NFPA 805 OBSERVATION VISIT TRIP REPORT

Date: March 27-30, 2006

Subject: Risk-Informed, Performance-Based Fire Protection Transition Pilot-Plant Observation Visit - Harris Nuclear Plant and Oconee Nuclear Station

NFPA 805 Pilot-Plant Implementation Issue Summary Sheet No. 1

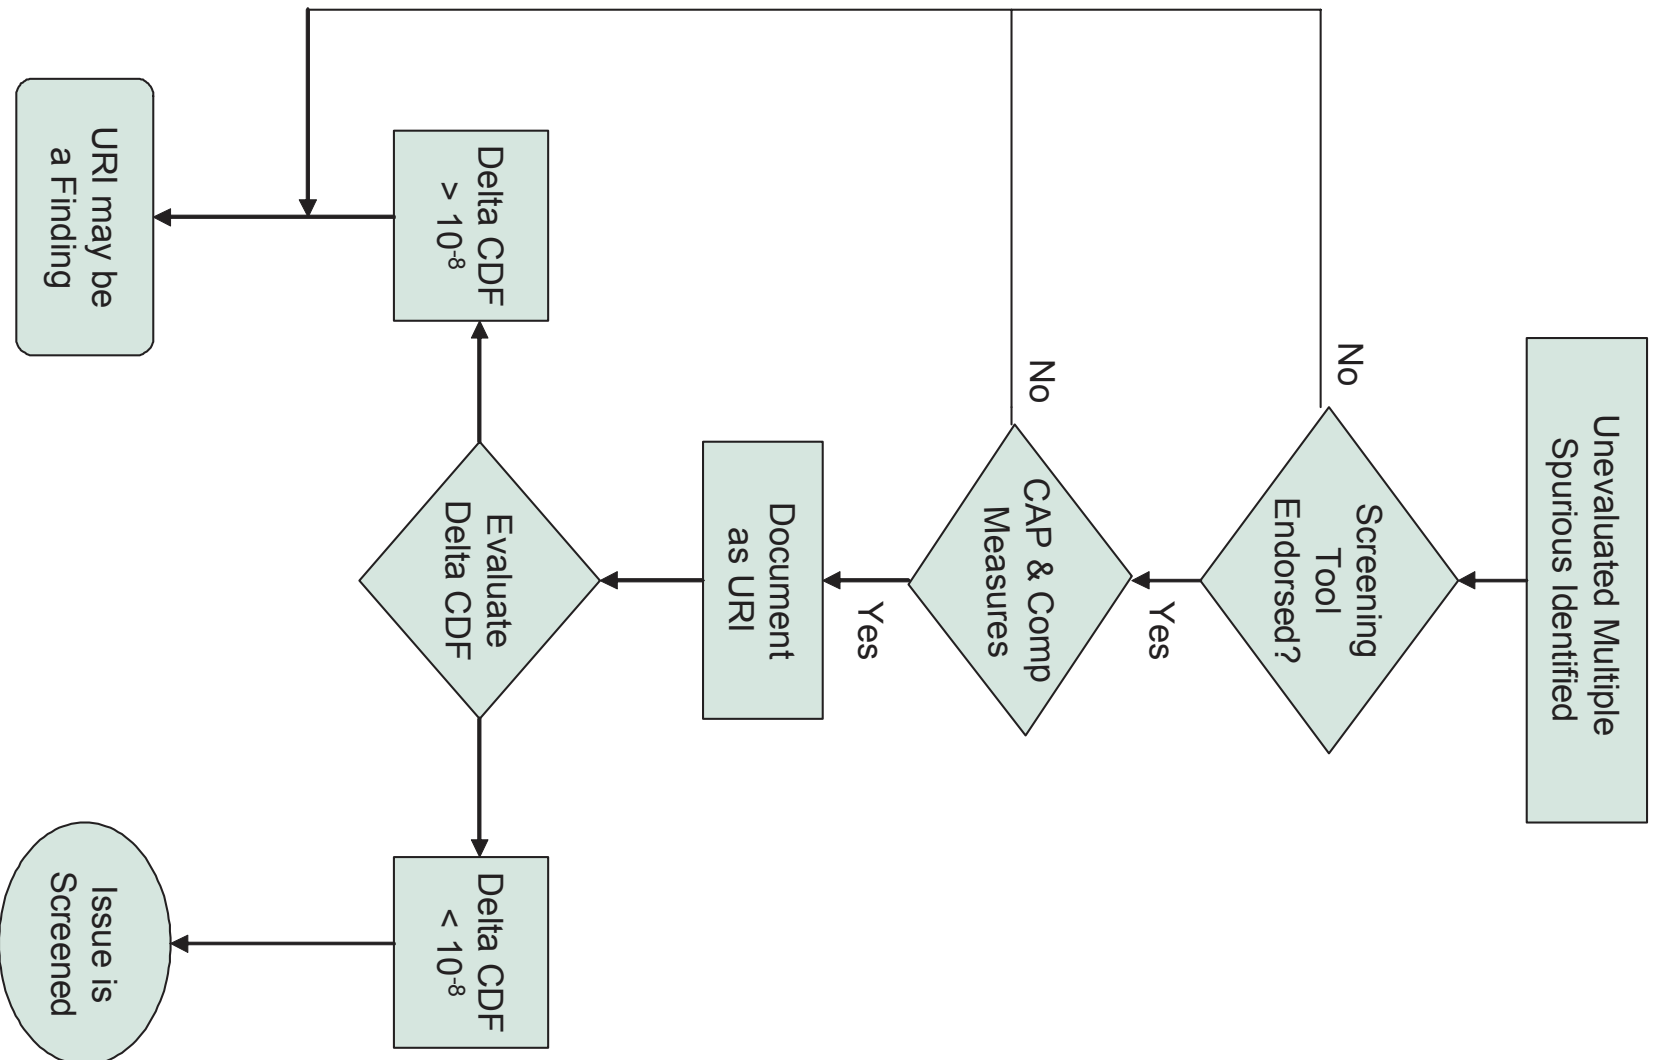
The NRC staff presented a flowchart during the March 2006 pilot plant observation meeting that illustrated how new multiple spurious operations (identified during inspections) would be treated (See flow chart below). In addition to the flowchart, the following information was also conveyed during the meeting:

- If the circuit issue identified by the inspector and its related contributors that were also omitted are “greater than Green” OR “constitute a violation of defense-in-depth” or “safety margins,” in spite of using an appropriate screening tool, that would constitute a minor violation. If the inspector determines that the licensee’s screening tool is flawed, that would constitute a violation. Here “related contributors” are those that are associated via the same root cause, fire scenario, or fire area.

- If the circuit issue identified by the inspector and its related contributors that were also omitted are “less than Green” AND “do not constitute a violation of defense-in-depth” or “safety margins” AND the licensee has used an appropriate screening tool, no further action is warranted. However, if the inspector determines that the licensee’s screening tool is flawed, that would constitute a minor violation.

The process outlined in the flowchart documents (new) unevaluated multiple spurious operations as unresolved items (URIs) and proposes a risk threshold below which the multiple spurious operation is screened (a potential threshold for such “treatment” of 1E-08/yr delta-CDF [1E-09/yr delta LERF] was offered for discussion). Industry raised the concern that documenting all

multiple spurious operations as URIs pending evaluation will create a significant cost and resource impact because all URIs must be formally dispositioned and even those classified as minor can require 1000 hours. Industry's preference would be to not treat the new multiple spurious as a URI, but to disposition the issue within the fire probabilistic safety assessment (PSA) process. Consensus was to review the minor questions in Inspection Manual Chapter (IMC) 0612, and suggest development of new questions if necessary such that multiple spurious operations below a certain threshold could be relegated to minor and treated accordingly.

Resolution Action(s)/Action Party: OPEN. Industry and pilot-plant participants agreed to review the flowchart, IMC 0612 questions, screening thresholds and provide feedback to the NRC at the next observation meeting. The industry may also submit an FAQ on the issue.
